61 MILPERRA ROAD, REVESBY, NSW 2212

Landscape Documentation for S4.55 Modification Application

Key Considerations

SSD-02

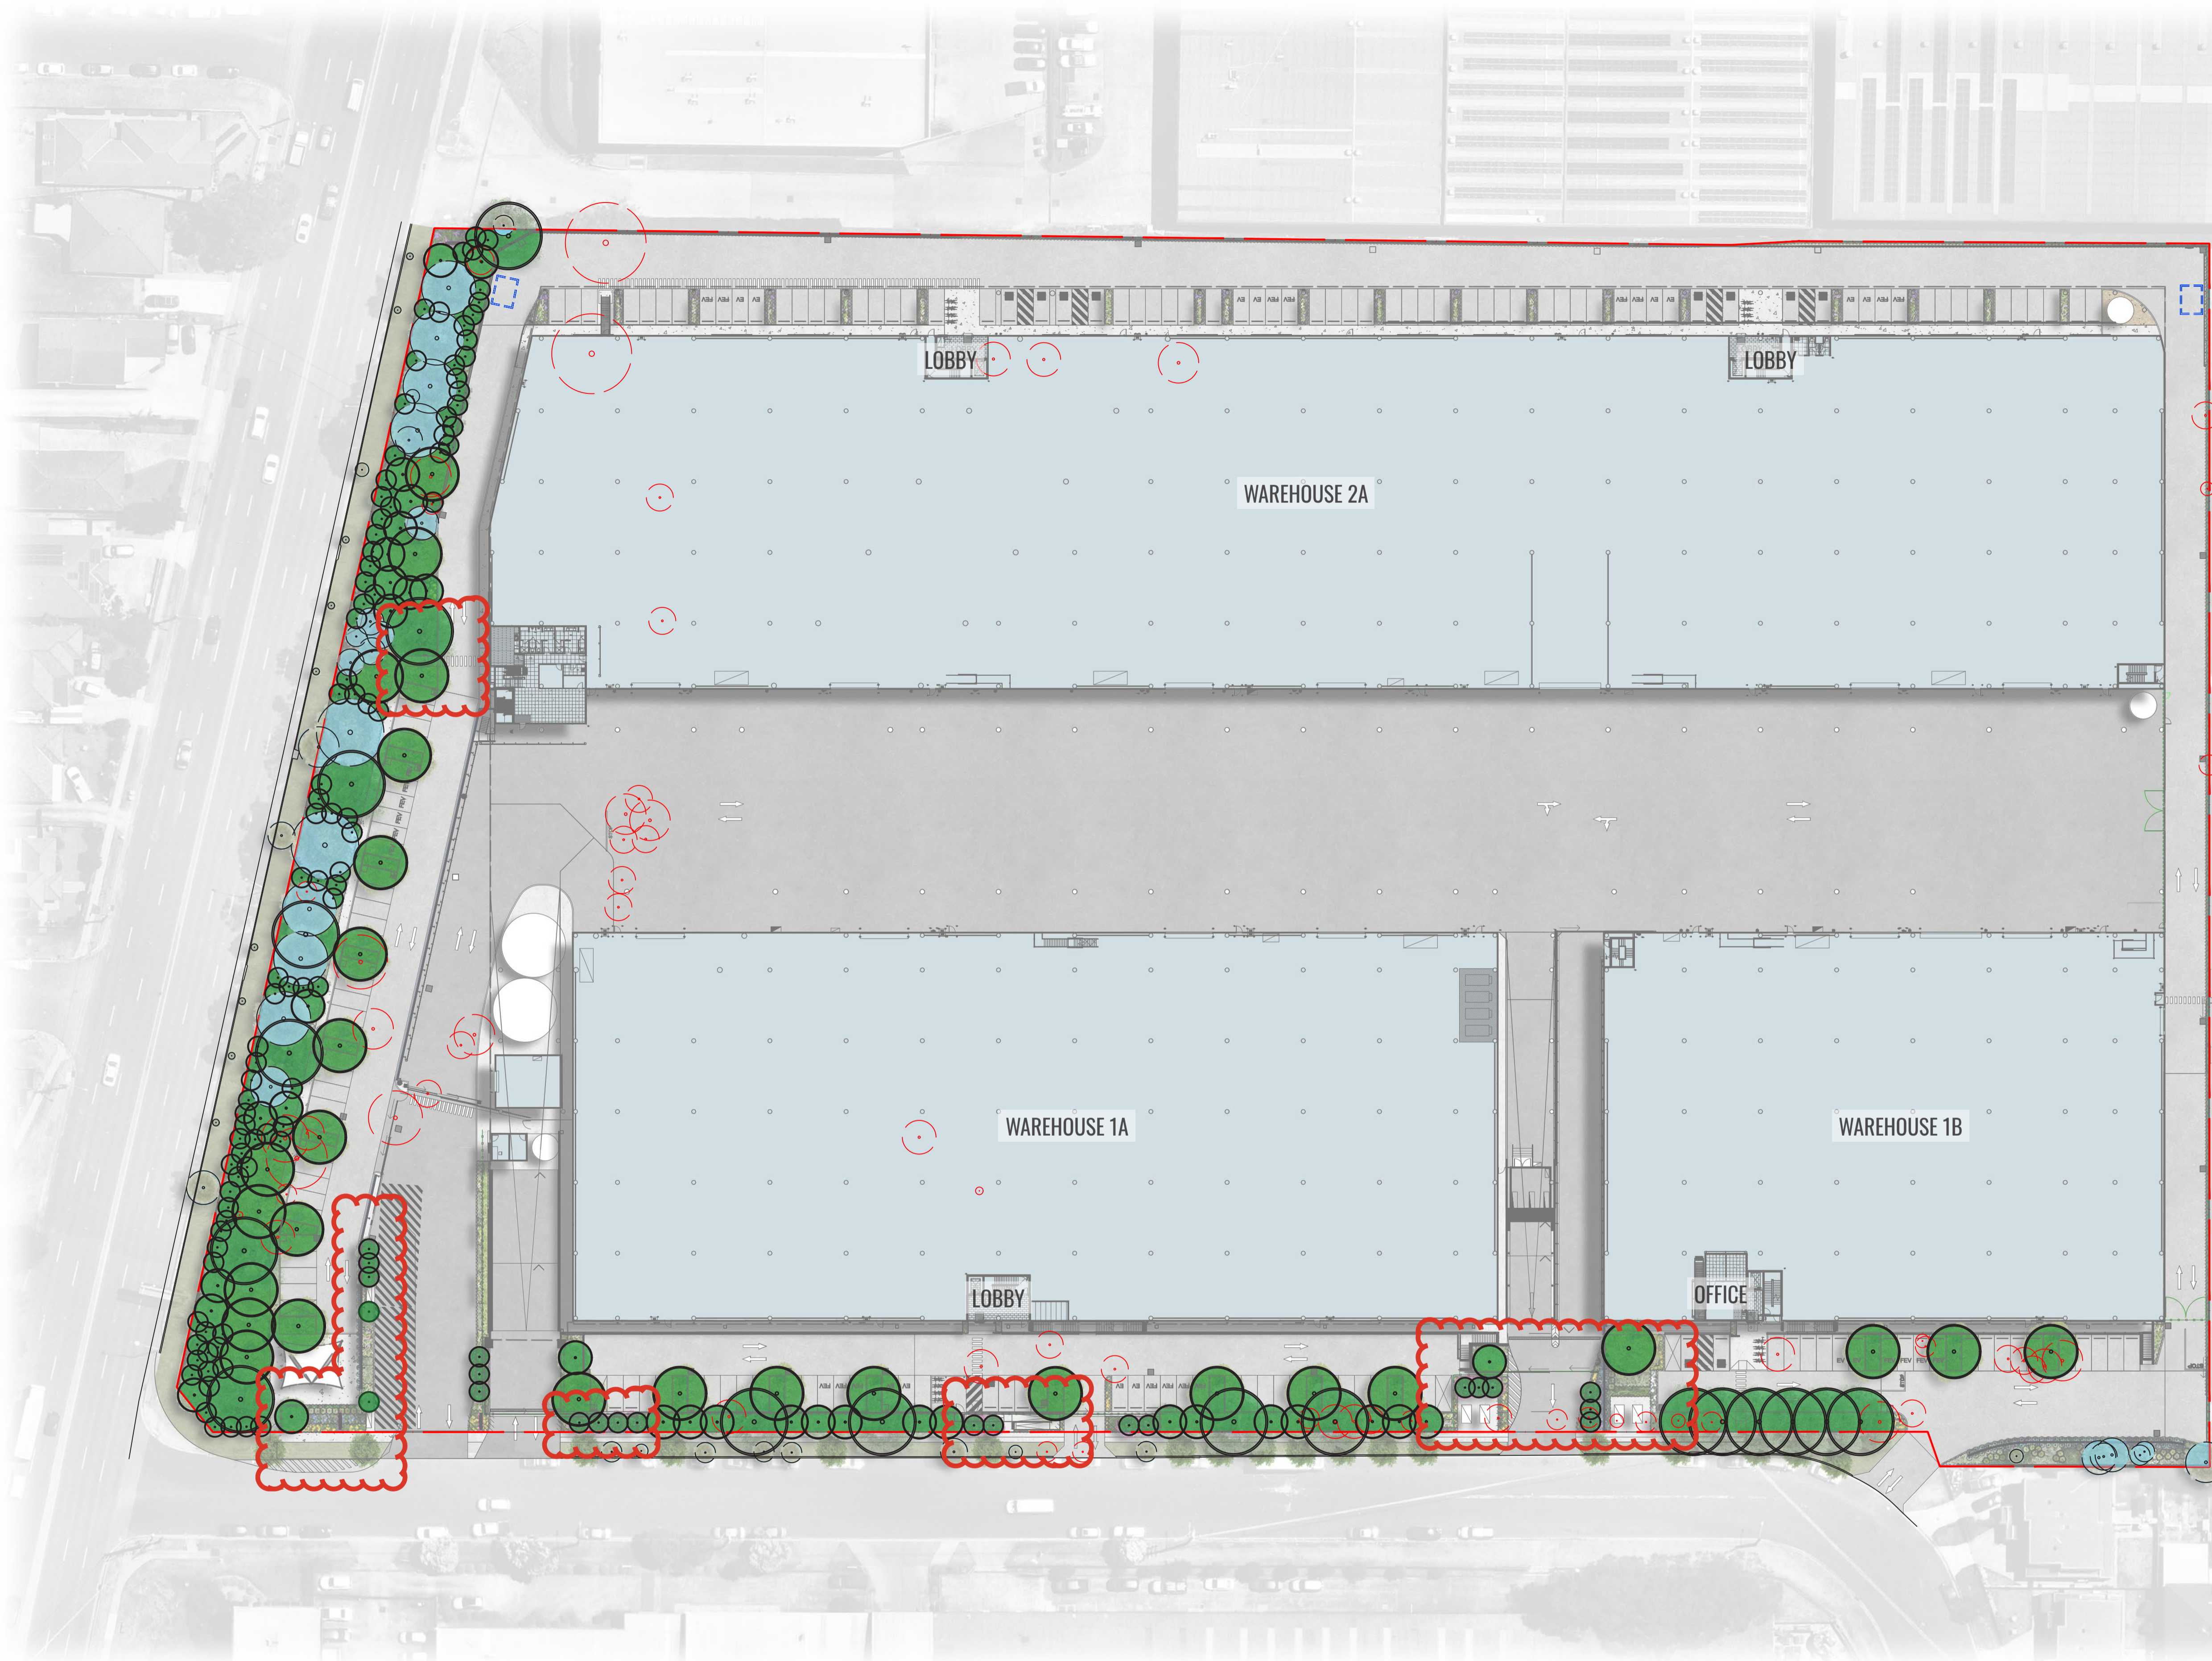
a. Allocating a minimum of 15% of the site area as deep soil with at least 20% canopy coverage;	The proposed landscaping achieves 6.3% deep soil and 7% canopy cover. Refer to SSD-02 for the Tree Canopy Plan.

Drawing Title:
Landscape GF Detail Plan - Sheet 1
 DWG No: **SSD-03**

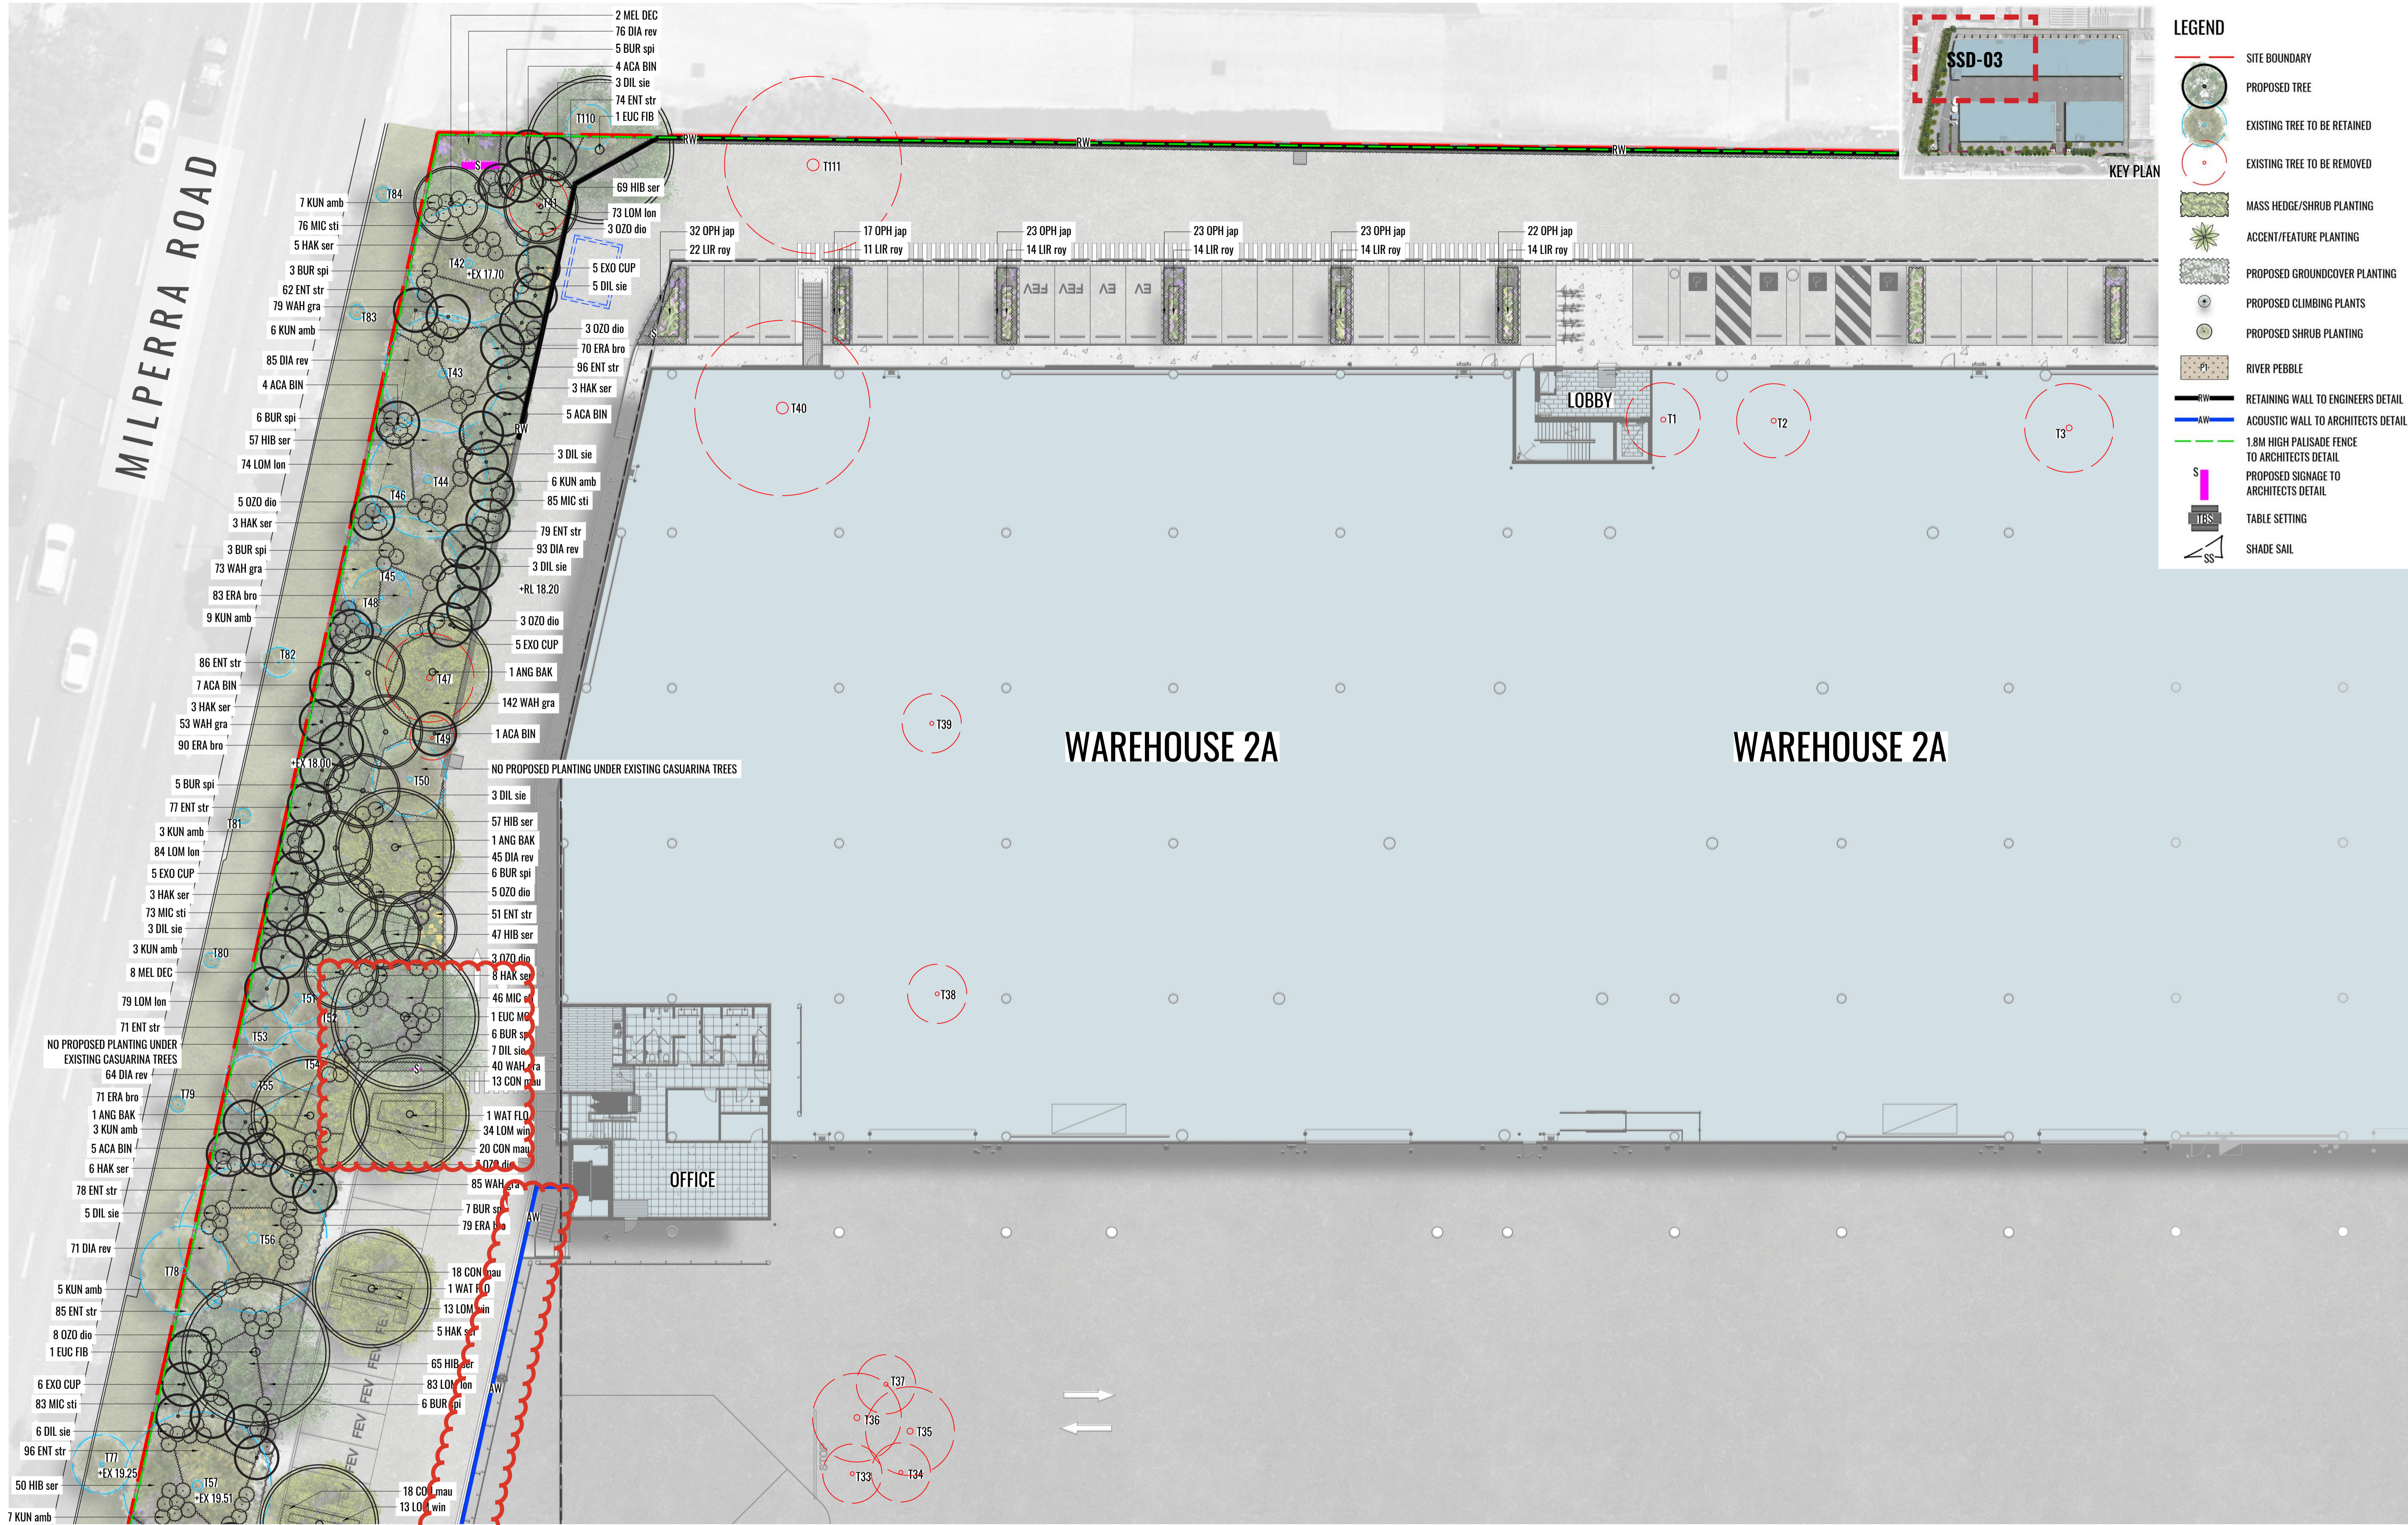
b. Include at least one medium-sized tree every fifth car parking space provided. These trees should be situated within a planted zone of 13 m ² , equivalent to the area of a standard car parking bay; and	Waterhousea floribunda trees are proposed at a rate of 1 per 5 car spaces. Refer to detail plans SSD-03 to SSD-05.

3. Council Requests that the proposal should prioritise the retention and protection of large canopy trees along Milperra Road facing the R2 Zone and existing trees along the eastern property boundary on Mons Street.	Existing trees have been retained where possible along the Mons Street frontage. Please refer to SSD-03 and SSD-04.
Landscaping
